Group 3 Body Equipment

Service Bulletin

ATTENTION: SERVICE MANAGERS		GROUP 3																		
<p>1. <u>DESCRIPTION</u></p> <p>This bulletin provides instructions for replacement of the roof mounted, hinged-type, AC condenser cover with a bolted-type cover.</p>		SUBJECT REPLACEMENT OF HINGED-TYPE AC CONDENSER COVER WITH BOLTED-TYPE COVER																		
<p>2. <u>EFFECTIVITY</u></p> <p>This modification will be incorporated on coaches 00001 through 00349 whenever a replacement cover is required.</p>																				
<p>3. <u>MANPOWER</u></p> <p>Estimated accomplishment time for one mechanic is 1 hour.</p>		MODEL (S) AFFECTED 2900R																		
<p>4. <u>MATERIAL</u></p> <p>Parts required to achieve this modification are as follows:</p>

ATTENTION: SERVICE MANAGER			GROUP 3
<p>1. <u>DESCRIPTION</u></p> <p>This bulletin provides instructions for adjustment of the driver and passenger doors to effectively seal door to coach frame. All of the kit components listed below will not be required for minor adjustments of a door. The entire kit is required if a major adjustment of the passenger door is required.</p>			SUBJECT PASSENGER AND DRIVER DOOR SHIM KIT
<p>2. <u>MATERIAL</u><

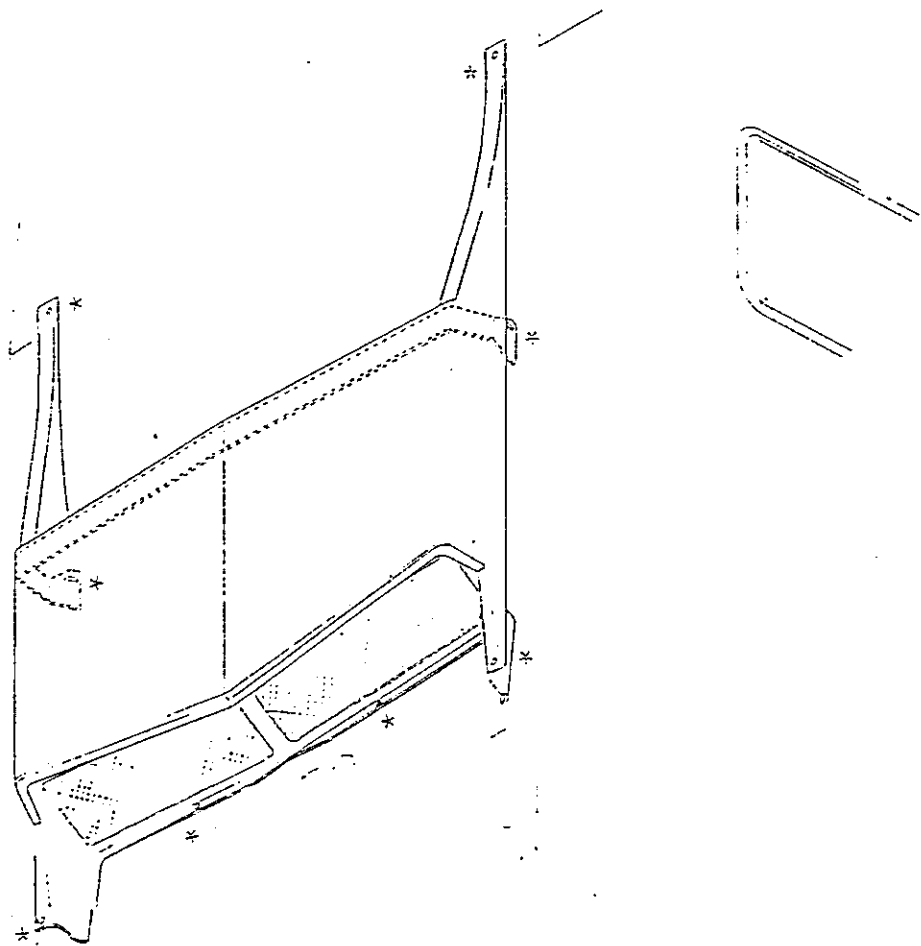
<u>TITLE</u>	<u>RVD P/N</u>	<u>QTY PER COACH</u>	Condenser cover assembly (bolted-type)	5101356-M01	1	Attaching hardware			Screw	M14290 (1/4-20 x 5/8)	8	Washer	M17024 (1/4 I.D. lock)	8	Jacknut (molly fastener)	M17146 (1/4-20)	8	<p>(Factory Use Only) Information added to:</p> <p>OWNER MANUAL (S)</p> <p>SERVICE MANUAL (S)</p> <p>PARTS MANUAL (S)</p> <p>WARRANTY MANUAL (S)</p> <p>OTHER</p>
<u>TITLE</u>	<u>RVD P/N</u>	<u>QTY PER COACH</u>																		
Condenser cover assembly (bolted-type)	5101356-M01	1																		
Attaching hardware																				
Screw	M14290 (1/4-20 x 5/8)	8																		
Washer	M17024 (1/4 I.D. lock)	8																		
Jacknut (molly fastener)	M17146 (1/4-20)	8																		
<p>5. <u>ACCOMPLISHMENT INSTRUCTIONS</u></p> <p>The procedure for installing the bolted-type condenser cover assembly (P/N 5101356-M01) is as follows:</p> <p>a. Locate cover assembly by centering between two roof fairings and over condenser as illustrated in figure 1.</p>

ATTENTION: SERVICE MANAGERS	GROUP
<p>b. Using holes in cover assembly (8 places per figure 1) as a template, drill through roof (fiberglass only) with 9/32 inch diameter drill bit.</p>	3
<p style="text-align: center;">CAUTION</p> <p>Do not drill beyond outer fiberglass shell thickness to avoid damage to interior lining material.</p>	SUBJECT REPLACEMENT OF HINGED-TYPE AC CONDENSER COVER WITH BOLTED-TYPE COVER
<p>c. Remove cover assembly and open up holes in roof to 7/16 inch diameter.</p>	MODEL (S) AFFECTED
<p>d. Insert Jacknut M17146 ("molly" fastener) into each hole until anchor is flush with surface.</p>	2900R
<p>e. Turn screw until snug in order to properly seat Jacknut M17146 ("molly" fastener), then remove screw.</p>	(Factory Use Only) Information added to:
<p>f. Position and align cover assembly and install screws with lockwashers (8 each) until tight as shown in figure 1.</p>	OWNER MANUAL (S)

Figure 2

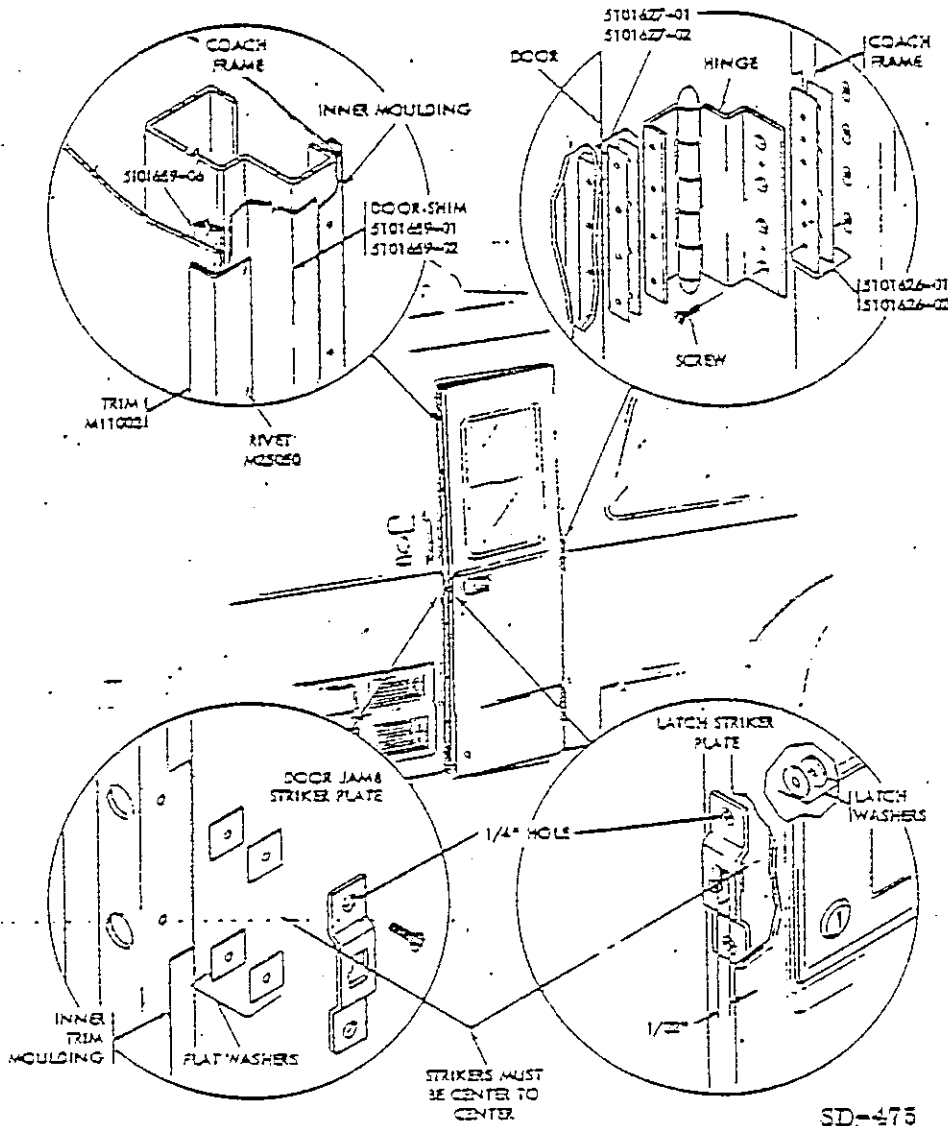
ATTENTION: SERVICE MANAGER	GROUP 3
<p>3. ACCOMPLISHMENT INSTRUCTIONS</p> <p>Each door has horizontal slots at the hinge attachment points for IN and OUT adjustment with the door frame. In addition, the door frame has vertical slots at the hinge attachment points for UP and DOWN adjustment of the door with the door frame. The adjustments below apply to the passenger door and can also be used for the driver's door.</p> <p>a. Vertical Adjustment. Coach door frame has vertical slots at hinge points for vertical adjustment of door. To adjust a "cocked" door to a vertical and parallel position with the inner coach frame, insert shim 5101627-01 or 5101627-02 between hinge and door. Insert shim or shims at either the upper or bottom hinge or if necessary at both hinges (see Figure 2) until door is vertical. Loosen only one hinge at a time and install shim.</p> <p style="text-align: center;">NOTE</p> <p>If only a slight adjustment is required, shimming may not be necessary. Loosen screws holding hinge to frame and move door to the desired position.</p> <p>b. Lateral Adjustment. Coach door has horizontal slots at hinge points for lateral adjustment of door to coach frame. To adjust a door that is out from the coach frame at either the top or bottom, insert shim or shims 5101626-01 or 5101626-02 between the hinge and frame of coach (see Figure 2). To move the top of the door "IN", install shim or shims at the bottom hinge; to move the bottom of the door "IN", install shim or shims at upper hinge. Loosen only one hinge at a time and install shim.</p> <p style="text-align: center;">NOTE</p> <p>If only a small adjustment is required, shimming may not be necessary. Loosen screws holding hinge to door and slide door in or out until flush with coach frame.</p>	SUBJECT PASSENGER AND DRIVER DOOR SHIM KIT
